RECEIPT DATE: 12/18/24 **ONSITE SEWAGE DISPOSAL SYSTEM** P 587903

APPROVAL DATE: 4/3/2025 (SP) **PERMIT: NEW CONSTRUCTION** A _____

PROPERTY ADDRESS: 548 Watersville Road

SUBDIVISION: Hay Meadow Overlook LOT: 3 TAX ID: _____

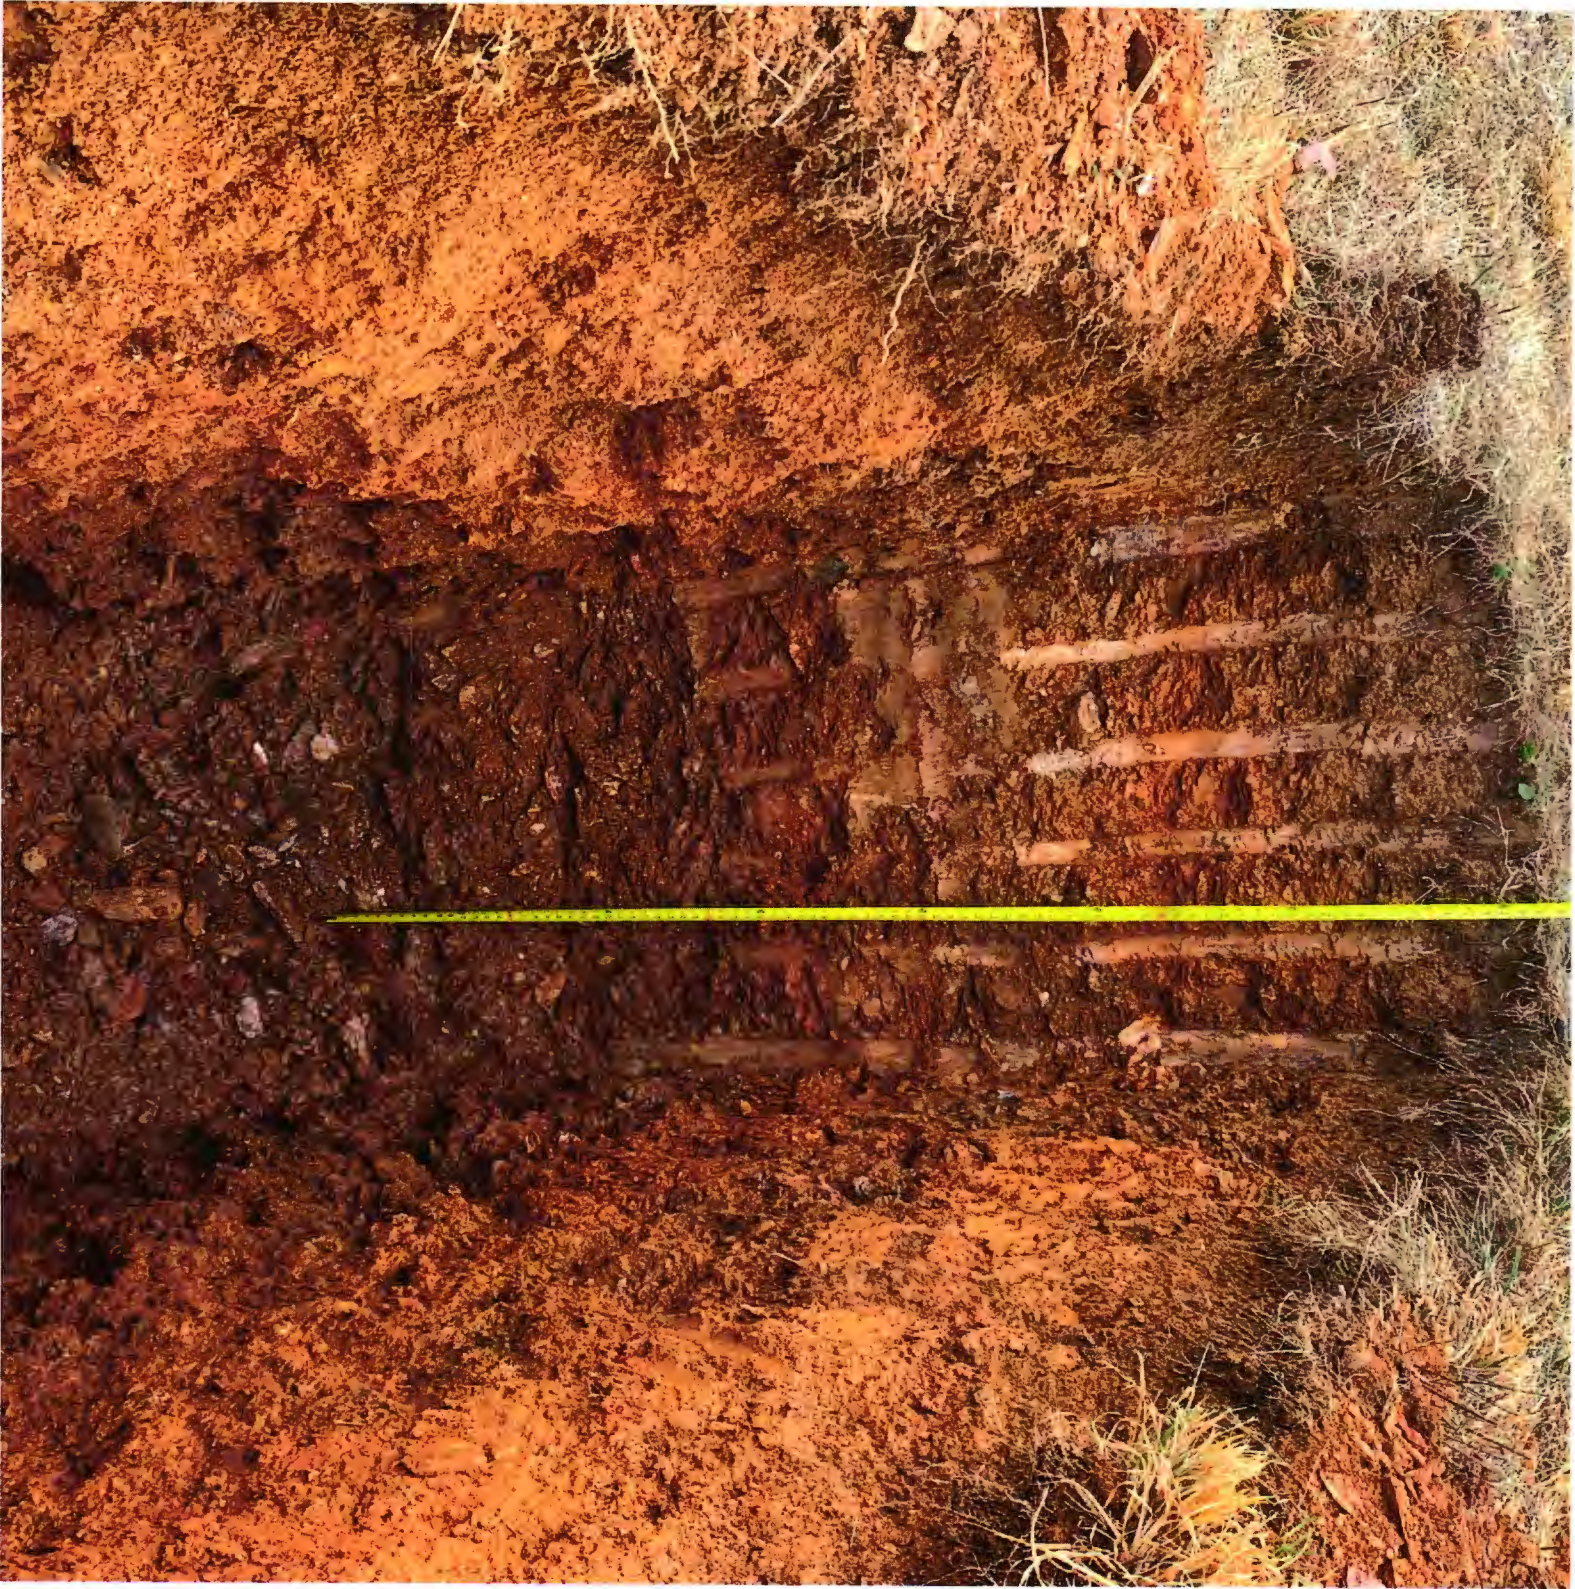
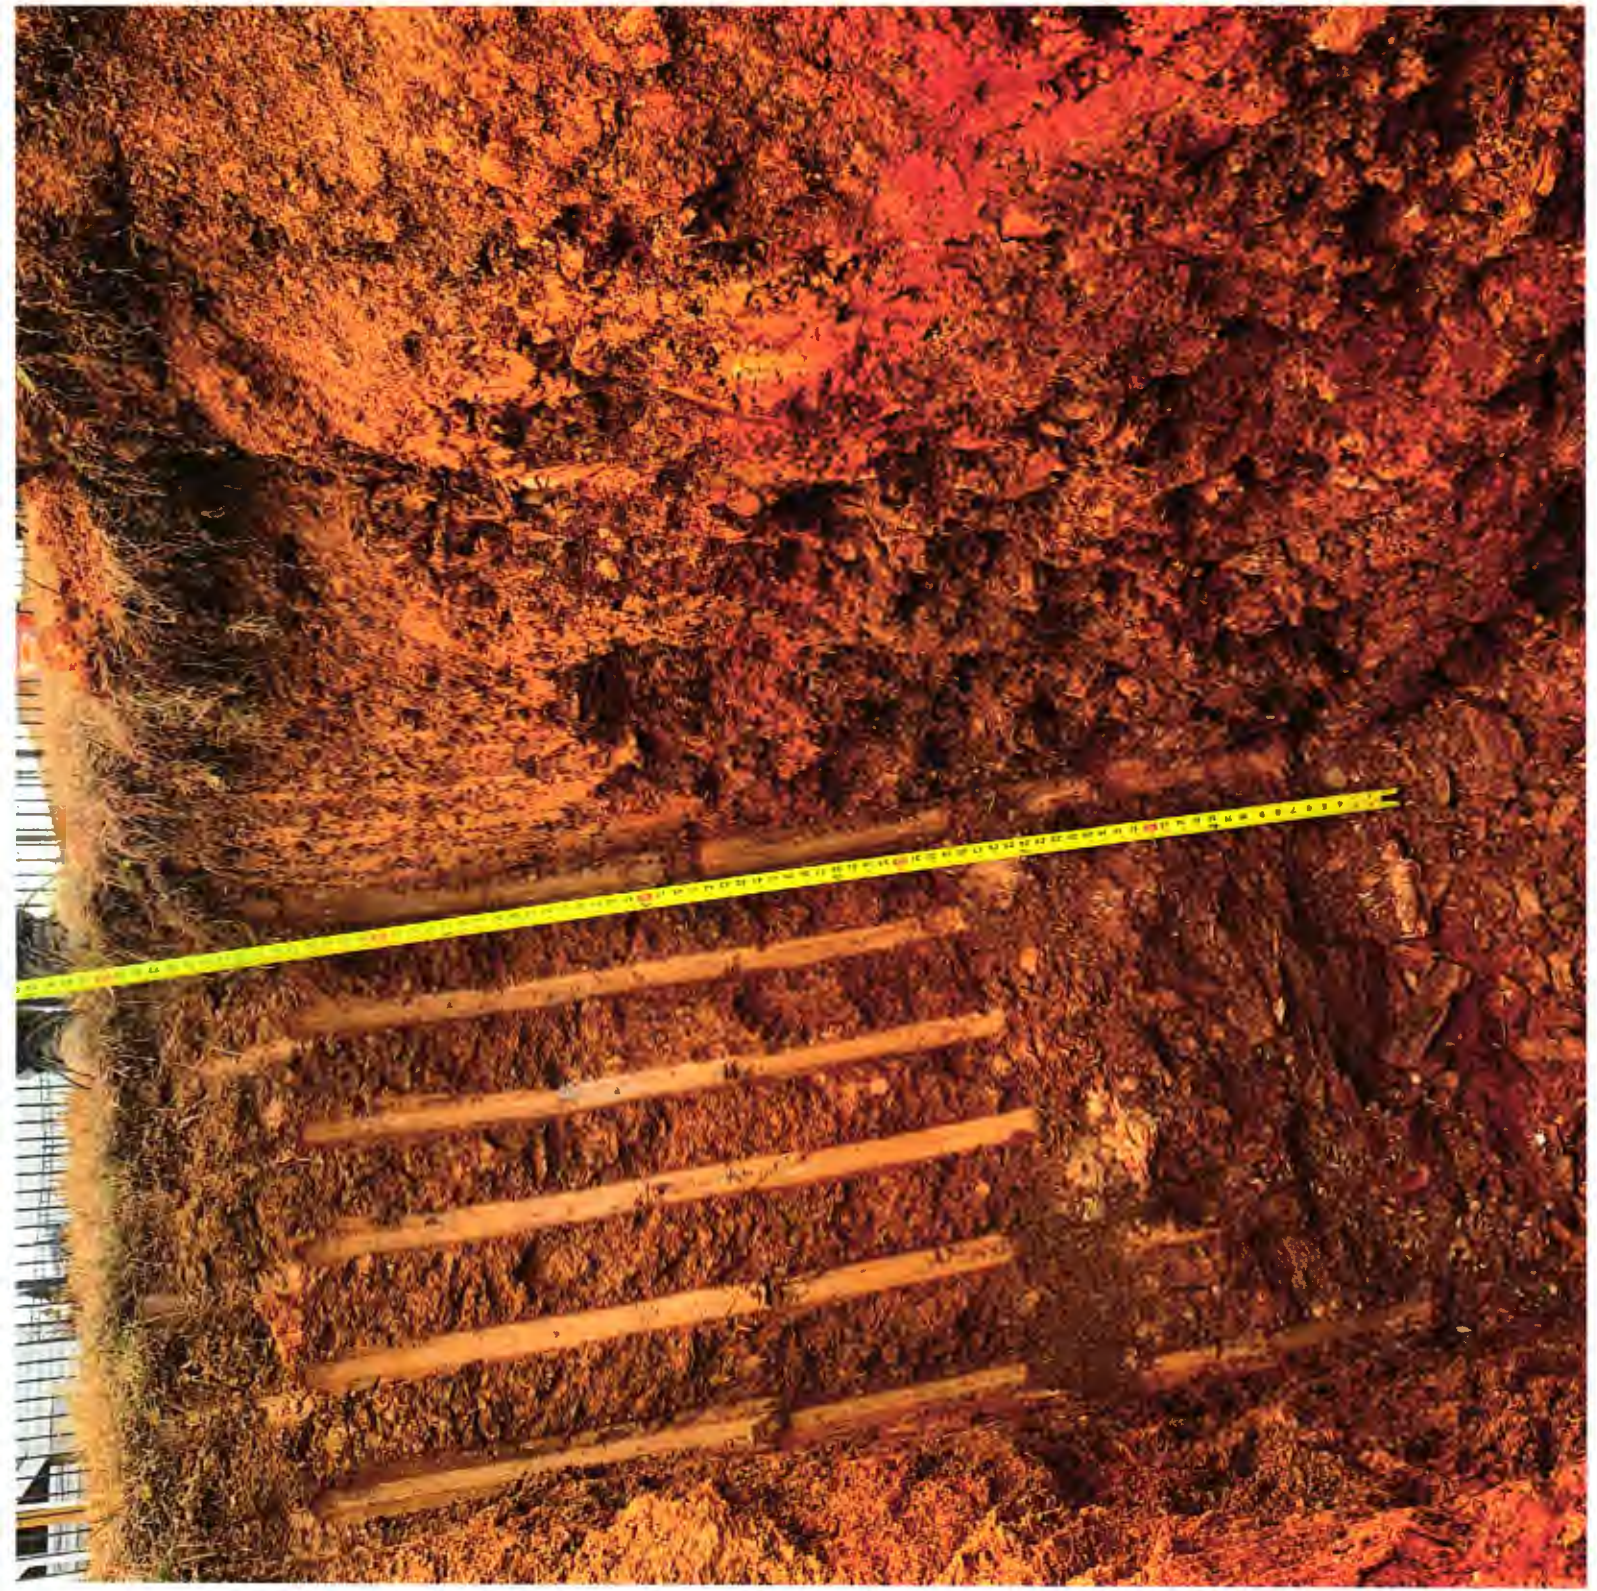
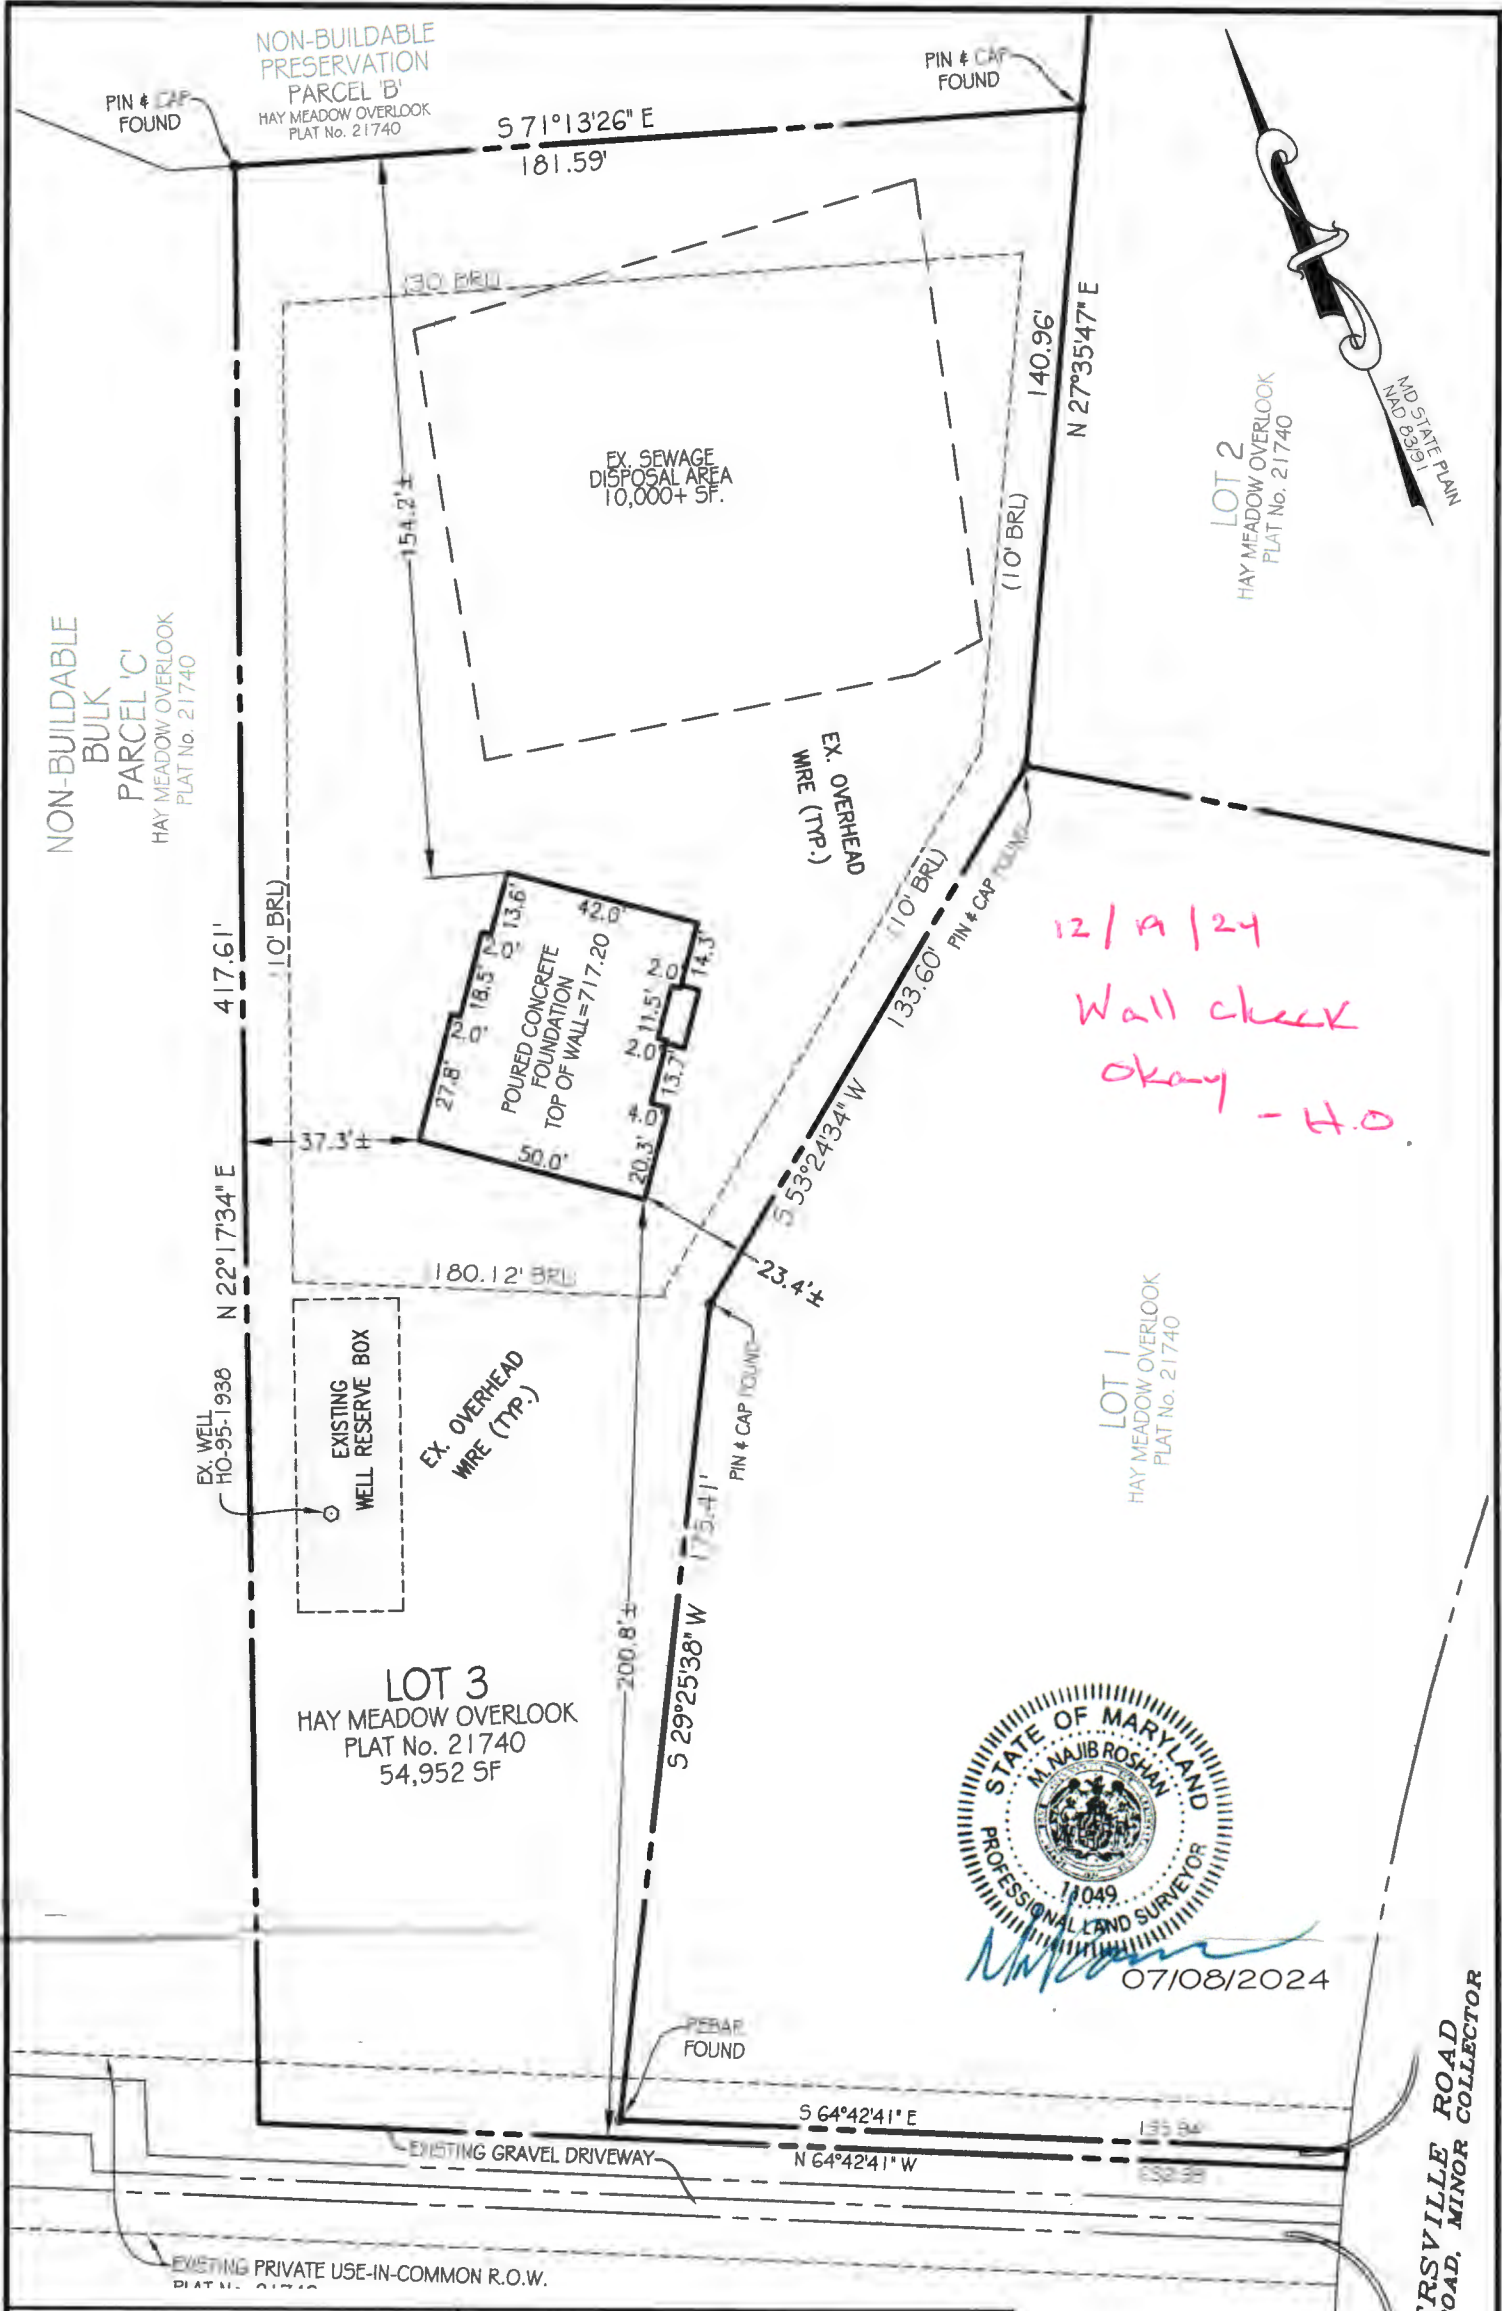
* System not installed
Per plan, 2 x 76' trenches
installed on area where
1st replacement system is *

2/14/2025 - Installer onsite for layout. measured 2 trenches @ 75',
went down with a 20' from tank below L.O. to make 2.5' inlet.
installer will make system to 2' inlet. Both trenches on
contour with h 1" + 13'-15' between trenches. ok to start install. (SP)
4/13/2025 - Email forwarded to engineer for revised plans (SP)

1/30/2025 - installer onsite for inspection. Route found in excavation hole for tank. installer using stone dust under tank. Enough fill
& front bar. seen do used L.O. seen installer dug a unit, & 2 replacement sites, found route in all holes. (SP/MB)

2/18/2025 - installer onsite for inspection. upper trench already dug & staked while onsite. stone dust. Soil test @ 30' of upper
trench bottom. rock seen @ 3'-5'. installer set perforated pipe while onsite & covered w/ stone. installer dug bottom
trench with rock @ 2.5'. moved trench into onsite. perforated pipe set & fabric on top over 10'-11' between
trenches. Levelled d-box while onsite, saw baffle & port. ok to install. (SP)

1/30/2025 548 Waterwillie Rd - 3 holes dug @ 1st + 2nd replacement, 3rd 1st replacement, + 2nd replacement. Each hole

2/18/2025 - on site while lower trench excavated
Rock @ 3'-5'. (SP)

2/18/2025 - onsite white lower trench
excavated. Rock @ 3'-5'. (sp)

2/18/2025 - Onsite while upper trench excavated
rock @ 3'-5'. (S6)
